**Subject: Cell 1 and Landfill Site Certification Addendum  
Enterprise Recycling & Disposal Facility  
Angelo's Aggregate Materials, Ltd.  
FDEP Permit Nos. 177982-001-SC, 177982-002-SO  
Pasco County, Florida**

Hartman and Associates, Inc. (HAI) is writing on behalf of Angelo's Aggregate Materials Ltd. (Angelo's), in response to preliminary review comments provided by the Department to Craig Bryan during a telephone conversation on October 22, 2003 regarding the above-referenced Certification application dated October 8, 2003. For your convenience, we have provided your comments (in bold typeface) for each of our responses.

FIGURE  
38

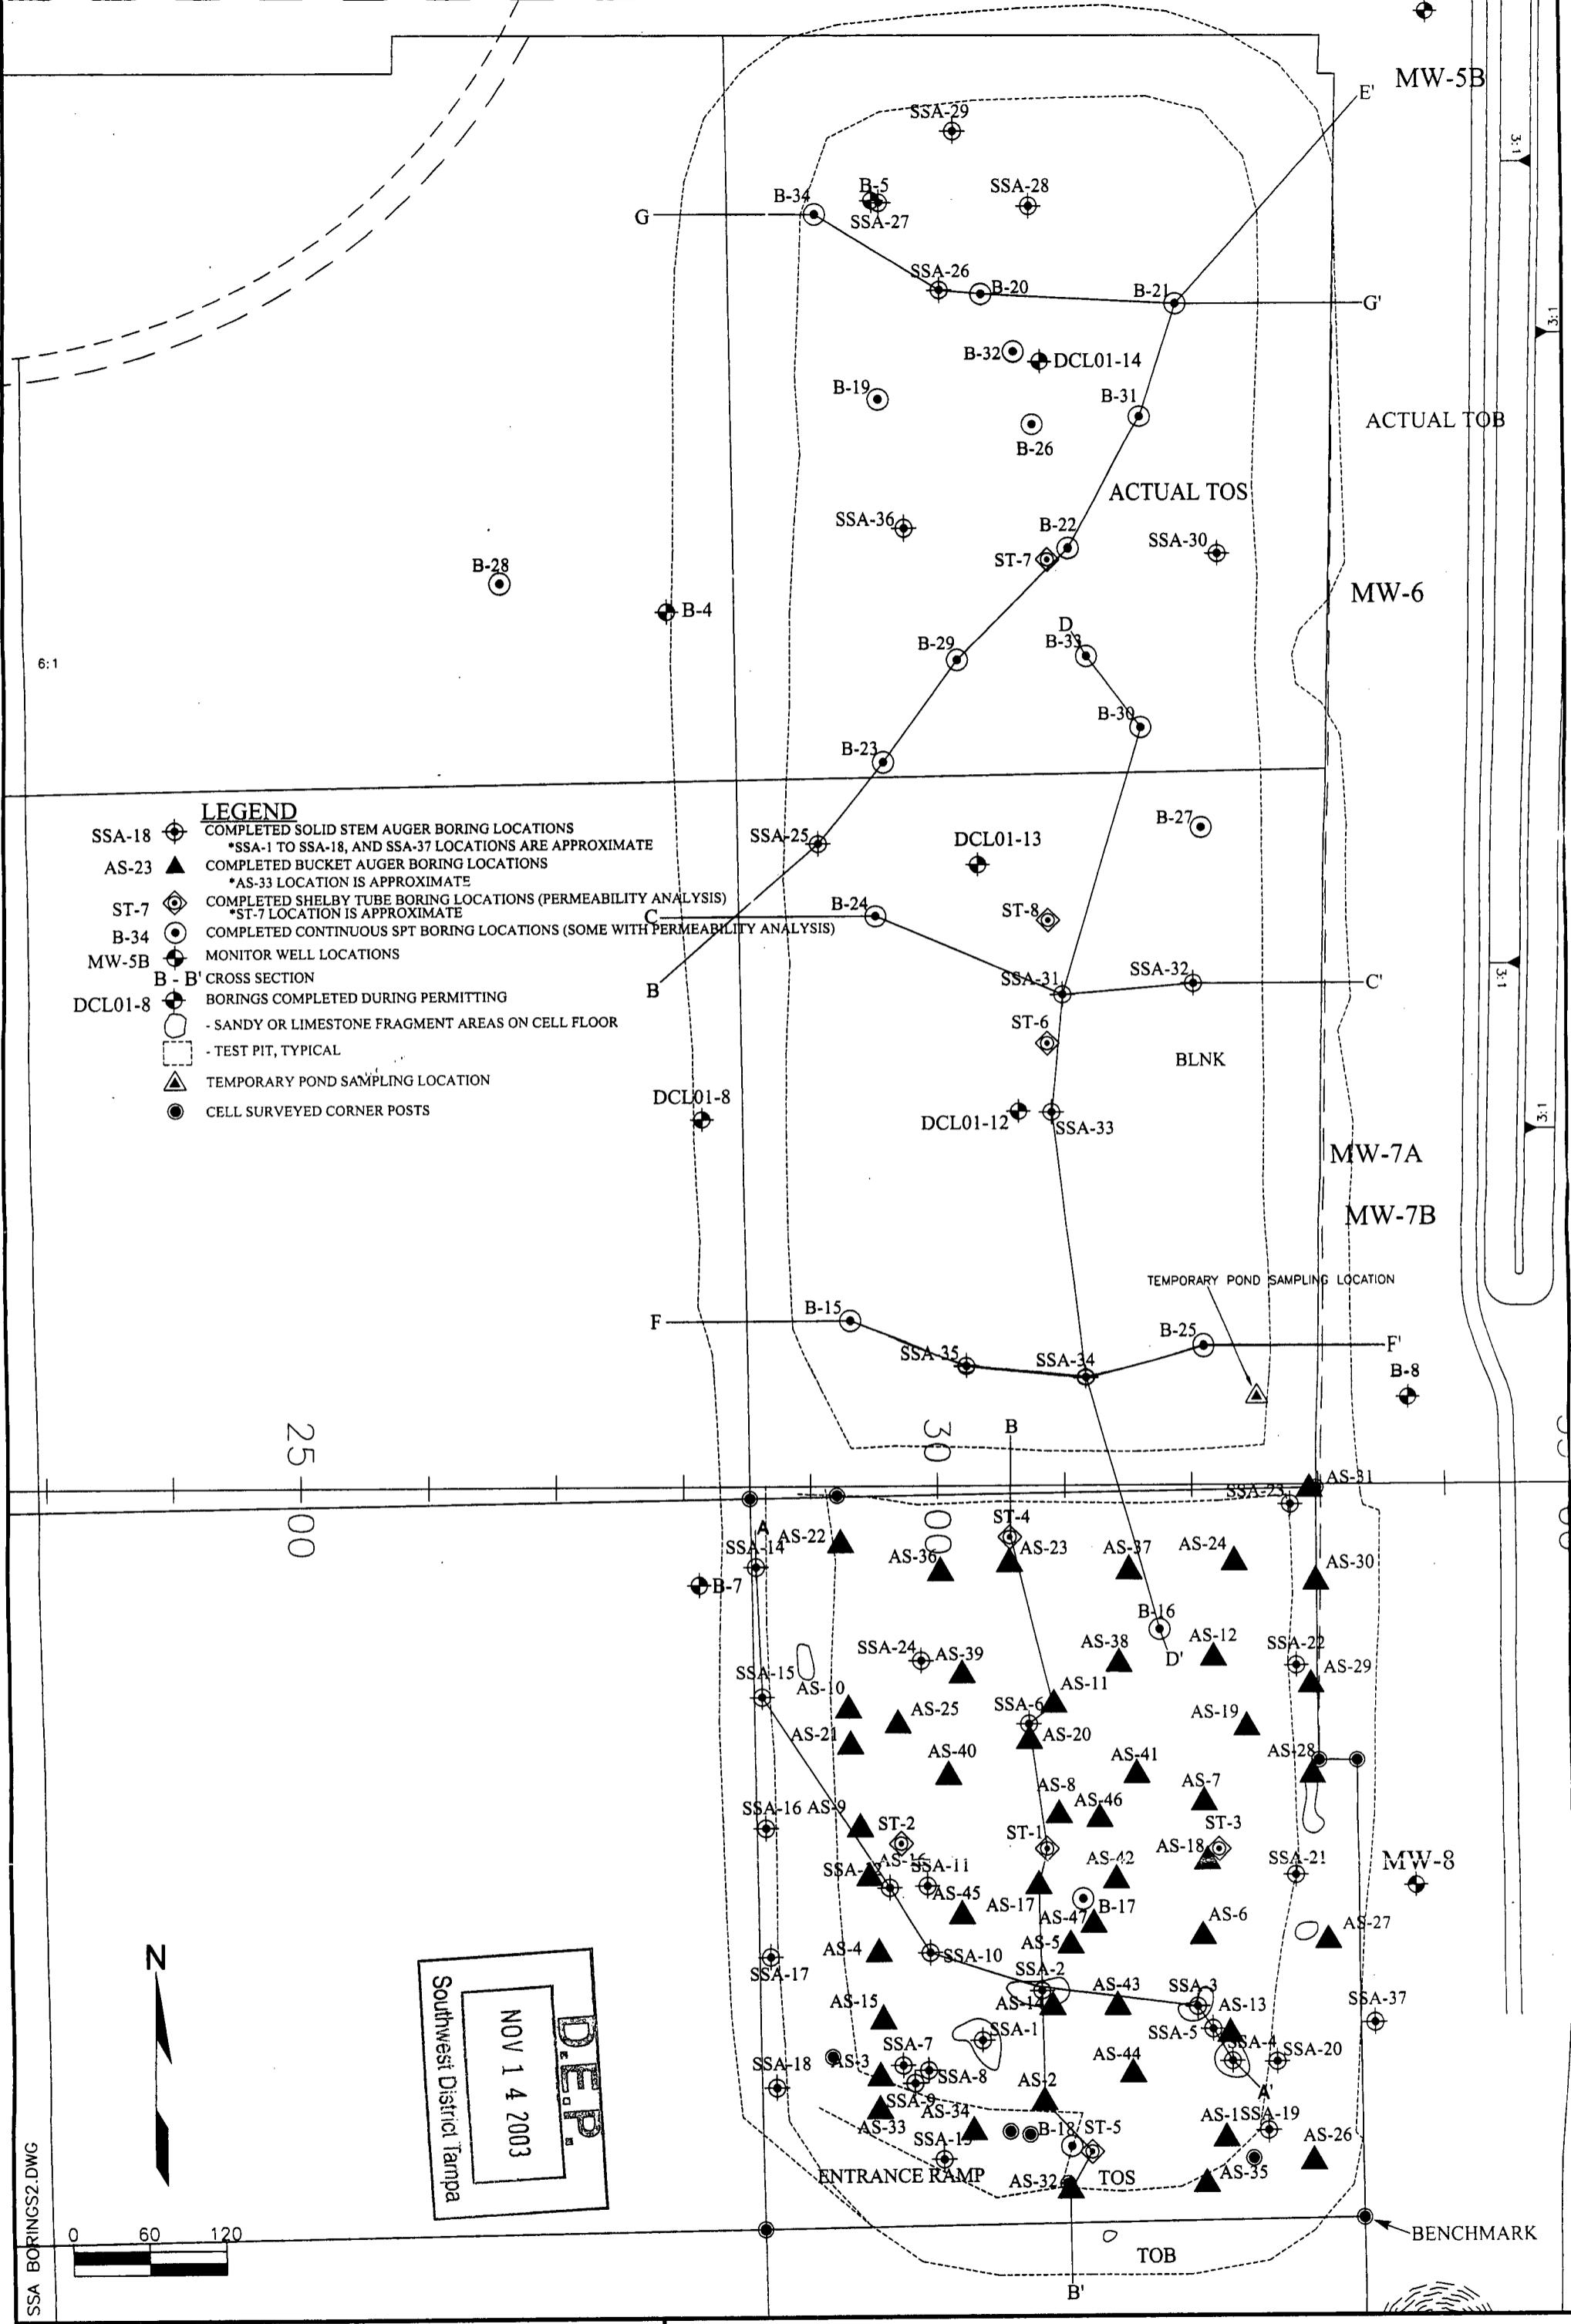
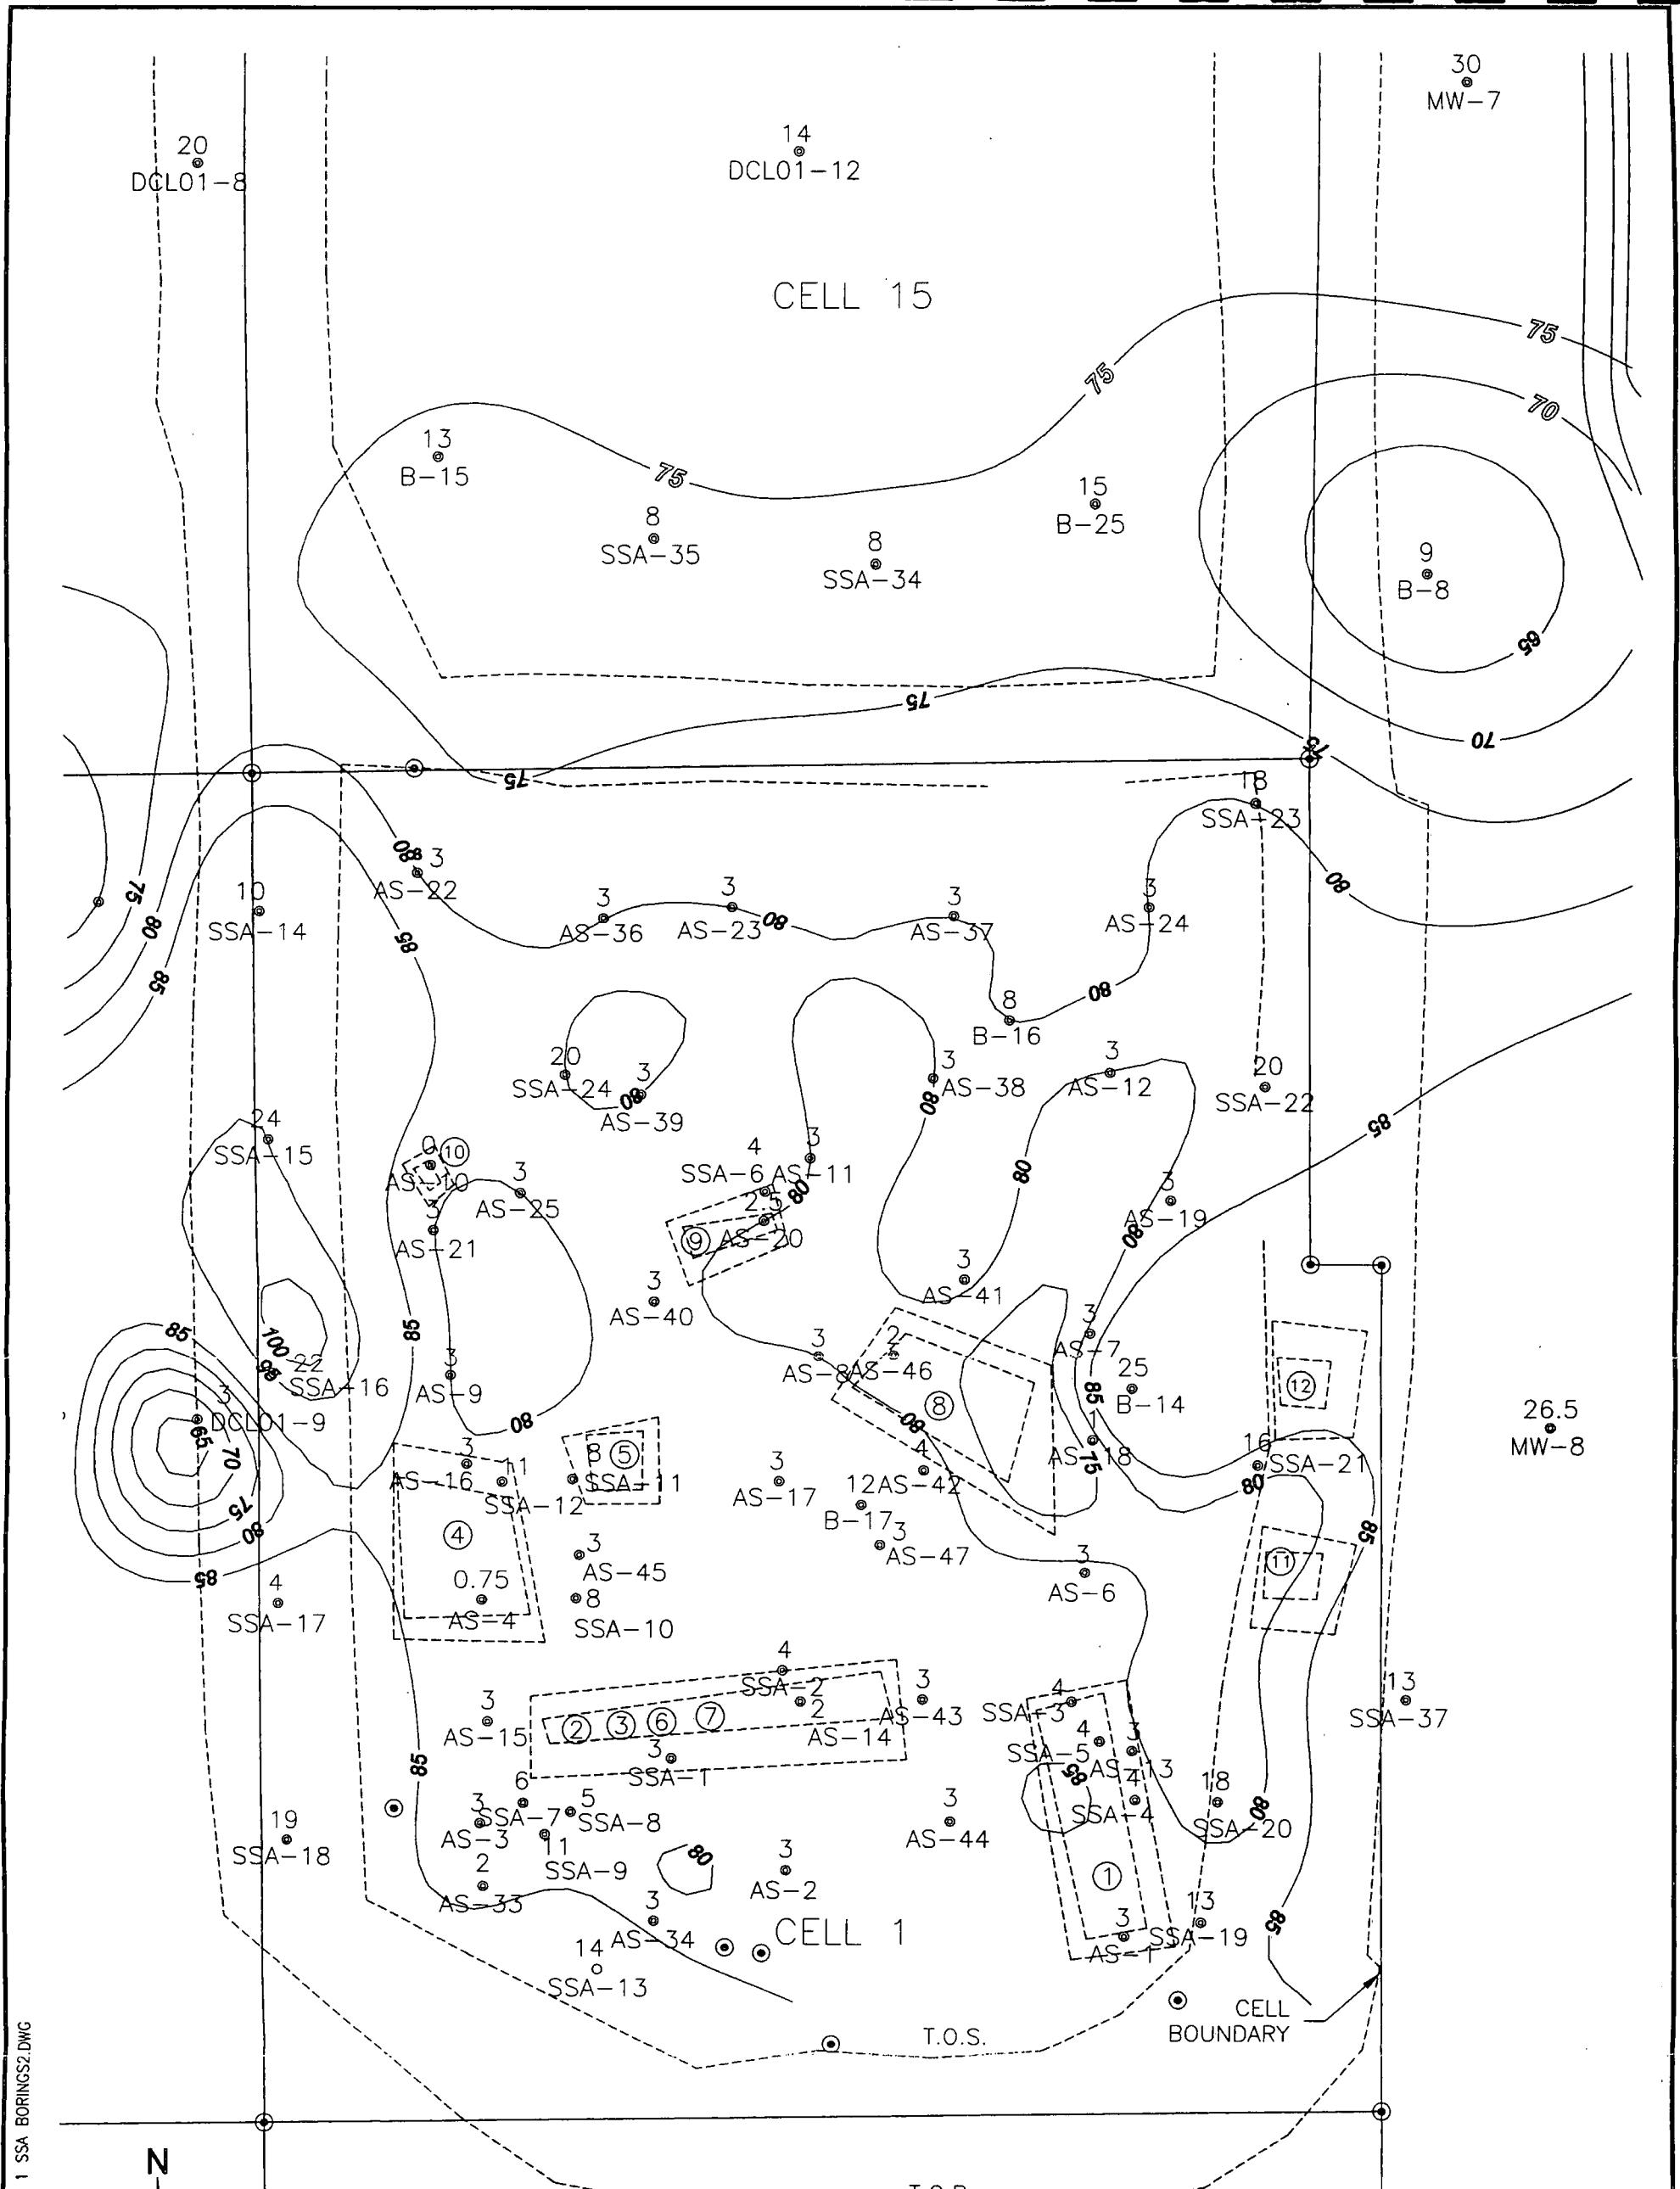
**7. The locations of the corner posts that define the area of waste disposal on the floor of Cell 1 were not included on all the maps submitted in the Certification Report.**

Response: The locations of the corner posts that define the area of waste disposal on the floor of Cell 1 were included in Appendix D, the signed and sealed survey from Foresight Surveyors, Inc. These locations have been included to Figures 1, and 38.

Specimen Identification	Classification				MC%	LL	PL	PI	Cc	Cu
● SSA-20 0.0					32

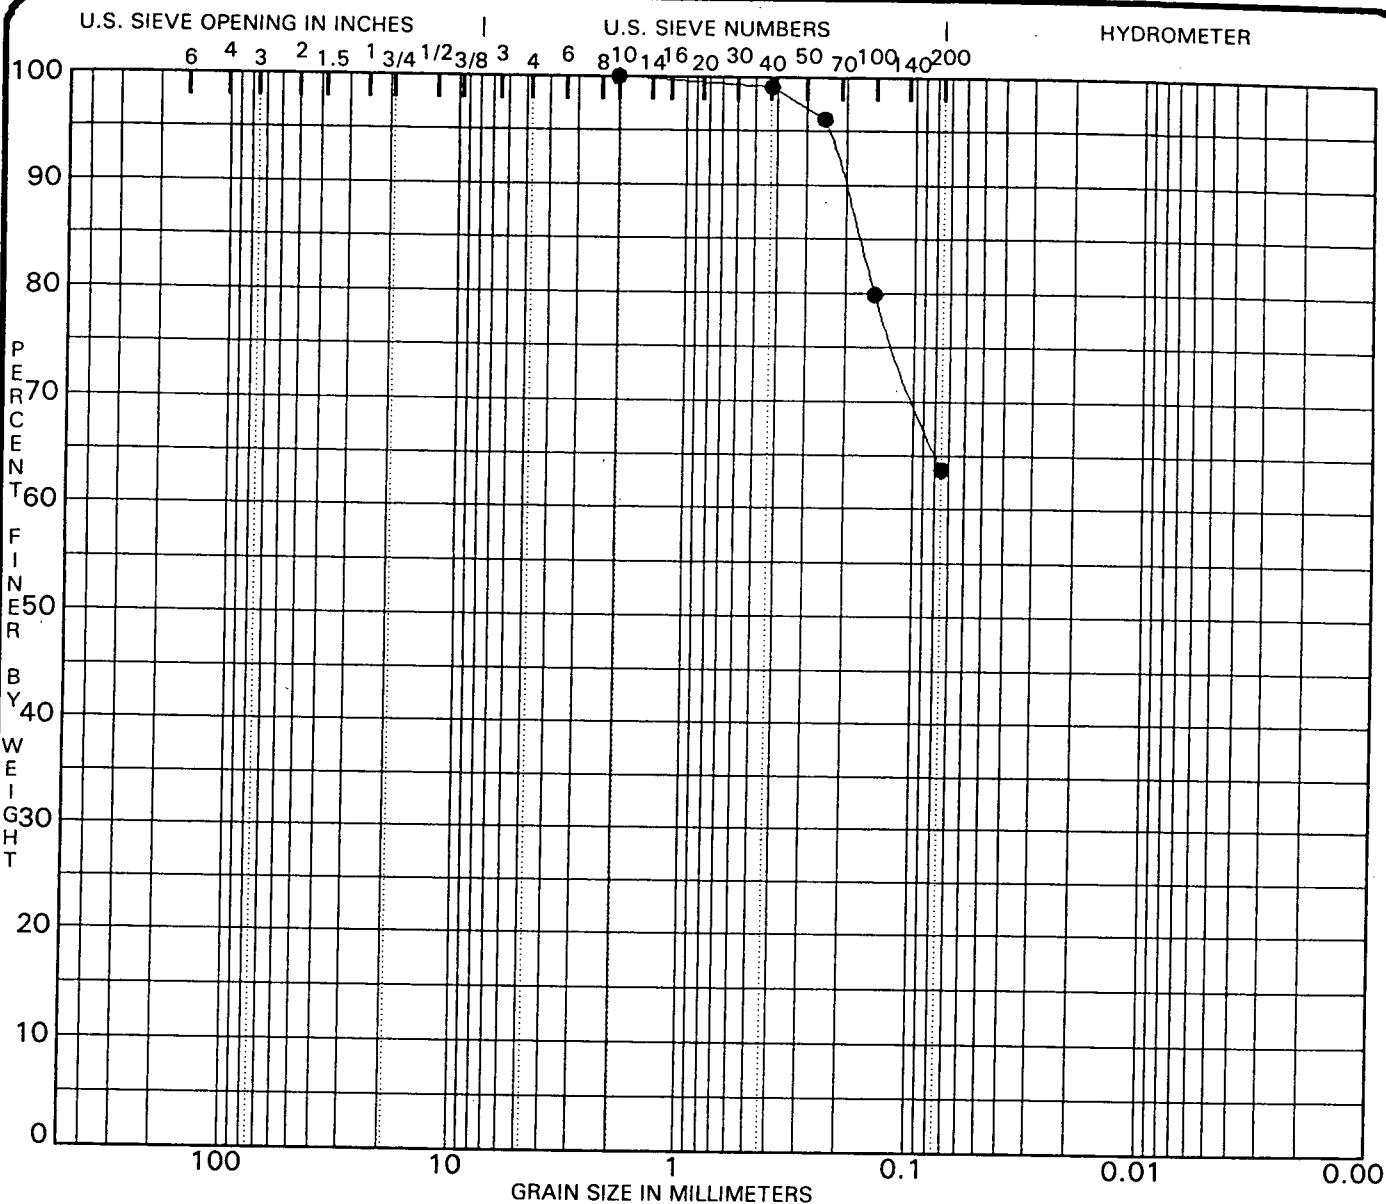
**4. The following boring intervals standard sieve analysis results did not meet the minimum 31% fines criteria for confining unit material: AS-42, SSA-20, SSA-13, SSA-17, and AS-10. Why were these results not addressed in the certification report?**

Response: The sieve analysis results for the above boring intervals were either excluded in the criteria evaluation because the boring location was excavated and replaced with confining unit material, or because a deeper interval was analyzed and resulted in a passing result of 31% fines. Specifically, AS-10 and AS-42 were located in sandy areas that were excavated and replaced with confining unit material. SSA-13 was located on the entrance/exit ramp to Cell 1 and is located outside the cell area be certified at this time. SSA-17 was located on the western slope and is not intended to be certified at this time. The sample from boring SSA-20, collected from a depth of 5'-10' BLS, resulted in

28.4% fines passing. A sample from boring SSA-20, collected from a depth of 20'-23' was submitted for standard grain size analysis. This sample resulted in 63.7% material passing. The results of this sieve and additional sieves that were not available at the time of the Certification Report submittal are included in Appendix B.
